PCN #: 2250

PCN Title: Change of Assembly Materials, Assembly Process and Mechanical Specification

**PRODUCT CHANGE NOTICE****PCN-2250 REV 00**

Figure 1: SOT-89 Changes

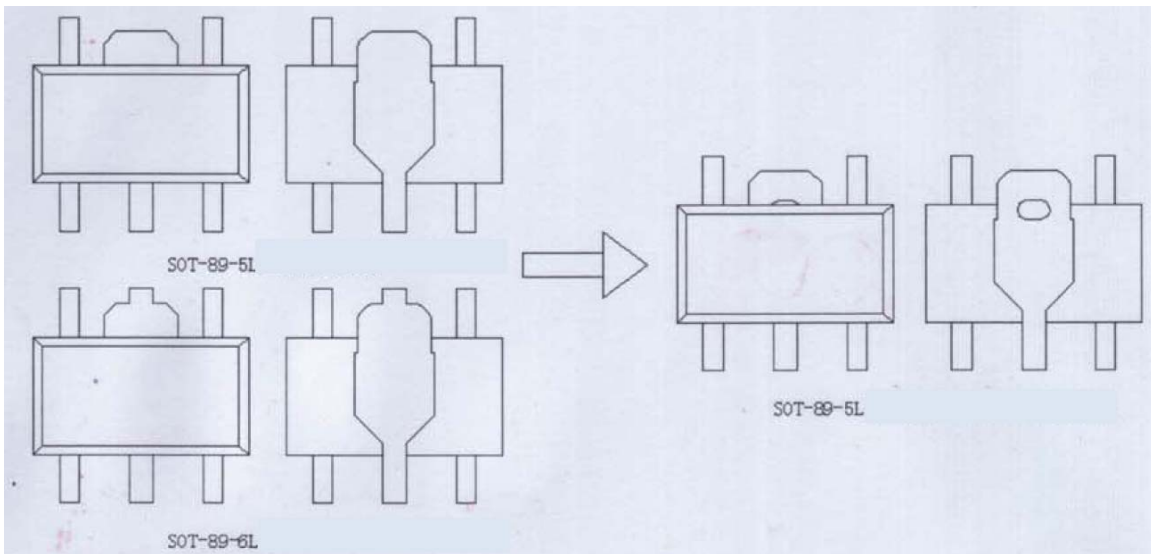
Table 3 - Leadframe Changes to SOT-89; See Figure 1					
AH9281RTR-G1	AP2112R5-1.2TRG1	AP2112R5-3.3TRG1	AP2112R5A-2.6TRG1	AP2115R5-2.5TRG1	AP2115R5A-2.5TRG1
AH9281RTR-G1	AP2112R5-1.8TRG1	AP2112R5A-1.2TRG1	AP2112R5A-3.3TRG1	AP2115R5-3.3TRG1	AP2115R5A-3.3TRG1
AH9282RTR-G1	AP2112R5-2.5TRG1	AP2112R5A-1.8TRG1	AP2115R5-1.2TRG1	AP2115R5A-1.2TRG1	
AH9282RTR-G1	AP2112R5-2.6TRG1	AP2112R5A-2.5TRG1	AP2115R5-1.8TRG1	AP2115R5A-1.8TRG1

**Figure 2: SO-16 Changes**

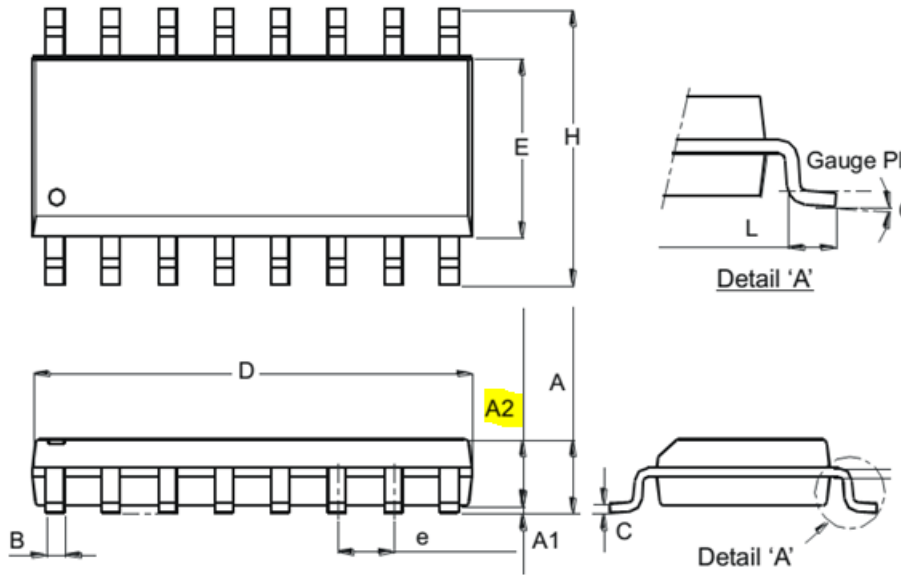
**Table 4 - POD Changes to SO-16; See Figure 2**

<b>From</b>	<b>To</b>
A2(mm) Nom	1.45	
A2(mm) Min	1.35	1.02
A2(mm) Max	1.55

Figure 3: QFN3030 Changes

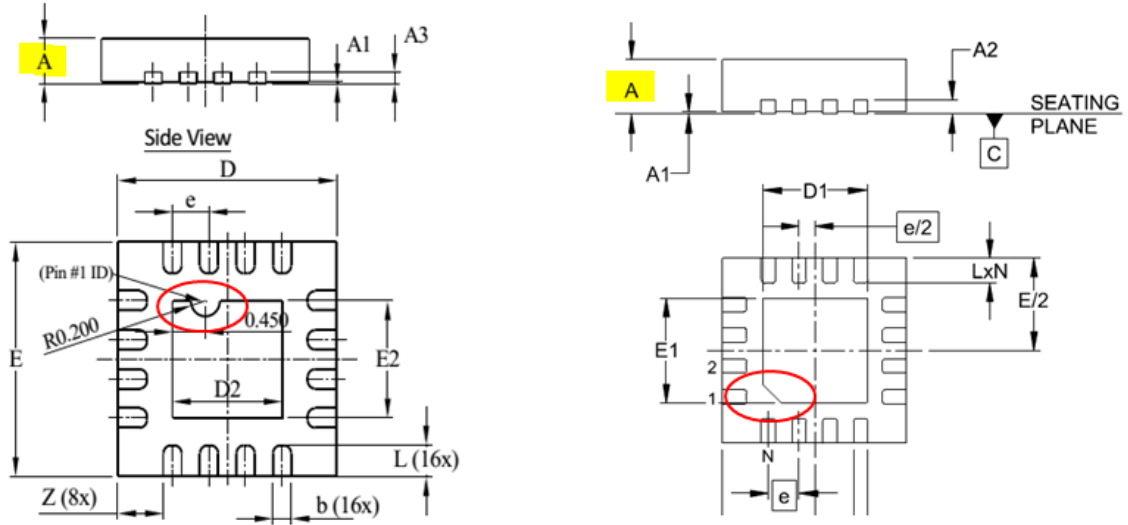
Table 5 - POD Changes to QFN3030; See Figure 3				
PAM8908JER

From	To
Pin #1 ID		
A(mm) Nom	0.5	0.6
A(mm) Min	0.4	0.55
A(mm) Max	0.6	0.65

Figure 4: QFN4040-16 Changes

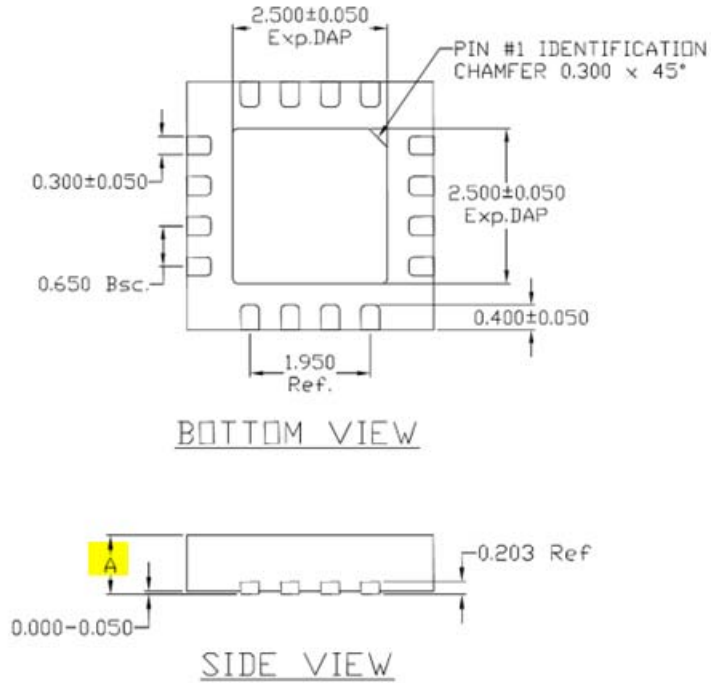
Table 6 - POD Changes to DFN4040; See Figure 4					
PAM8902KER	PAM8902HKER

<b>From</b>	<b>To</b>
A(mm) Nom	0.75	0.6
A(mm) Min	0.7	0.55
A(mm) Max	0.8	0.65

Figure 5: QFN4040-20 Changes

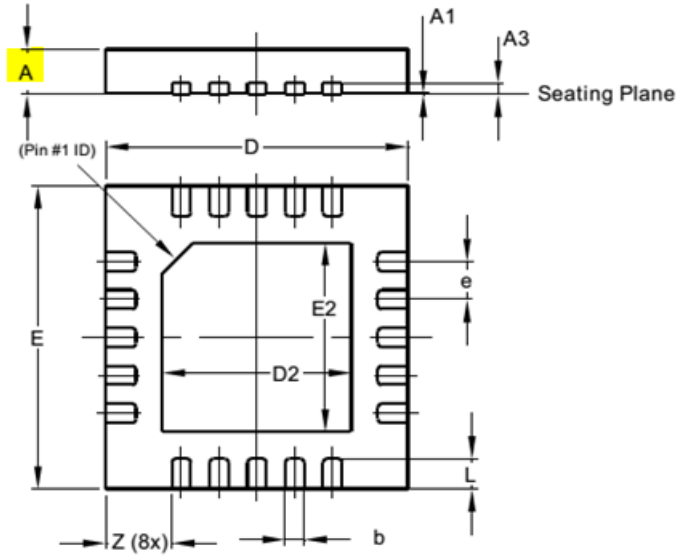
**Table 7 - POD Changes to QFN4040; See Figure 5**

<b>From</b>	<b>To</b>
A(mm) Nom	0.75	0.6
A(mm) Min	0.7	0.55
A(mm) Max	0.8	0.65

Figure 6: QFN5050 Changes

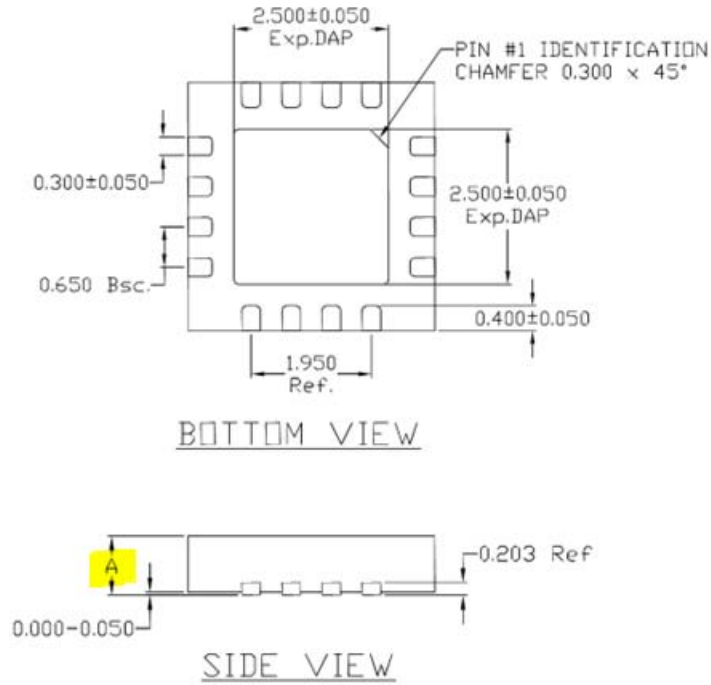
**Table 8 - POD Changes to QFN5050; See Figure 6**

<b>From</b>	<b>To</b>
A(mm) Nom	0.75	0.6
A(mm) Min	0.7	0.55
A(mm) Max	0.8	0.65
